Access Compliance Report

Public Rights-of-Way

(Curb Ramps)

Intersection ID: N/A	Main Street: TRYON_ST	Cross Street: MCDOWELL_FARMS_DR	Location: NE
ADA ID: 9D4B5F89E163	Ramp Type: Perp	Initial Pass/Fail: Fail	Overall Compliance: No
Severity Score: 12.5			
Codes/Mitigation Info/Possible Solution		Field Measurements/Component Compliance

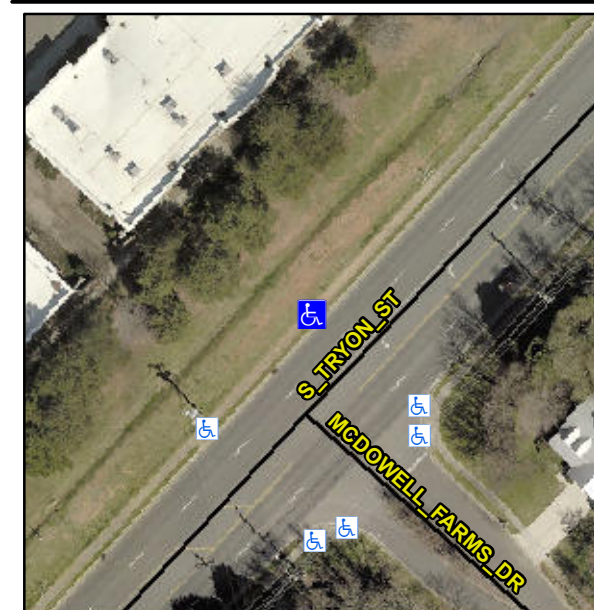
Compliance	Description	Data	Compliance	Description	Data
N/A	Ramp Length (in)	86.0	No	Ramp Slope (%)	9.1
Yes	Ramp Width (in)	49.0	Yes	Ramp XSlope (%)	1.4
N/A	Flare Type LT	N/A	N/A	Flare Type RT	N/A
N/A	Flare Slope LT (%)	N/A	N/A	Flare Slope RT (%)	N/A
N/A	Flare Traversable LT?	N/A	N/A	Flare Traversable RT?	N/A
N/A	Landing Length (in)	N/A	N/A	DWS Provided?	N/A
N/A	Landing Width (in)	N/A	N/A	DWS Contrast?	N/A
N/A	Landing Slope (%)	N/A	N/A	DWS Length (in)	N/A
N/A	Landing X Slope (%)	N/A	N/A	DWS Full Width?	N/A
N/A	Landing Curb? (Y/N)	N/A	N/A	DWS Offset (in)	N/A
N/A	Shared Landing?	N/A			
N/A	Gutter Ponding?	N/A	N/A	Gutter Slope (%)	N/A
N/A	Gutter Lip Ht (in)	1.0	N/A	Gutter X Slope (%)	N/A
N/A	Painted X Walk1?	No	N/A	Painted X Walk2?	N/A
	X Walk 1 Direction	To SE		X Walk 2 Direction	N/A
N/A	X Walk 1 Width (in)	N/A	N/A	X Walk 2 Width (in)	N/A
	X Walk 1 Slope (%)	2.8		X Walk 2 Slope (%)	N/A
	X Walk 1 X Slope (%)	0.5		X Walk 2 X Slope (%)	N/A

Possible Solutions:

Remove & Replace Entire Ramp.
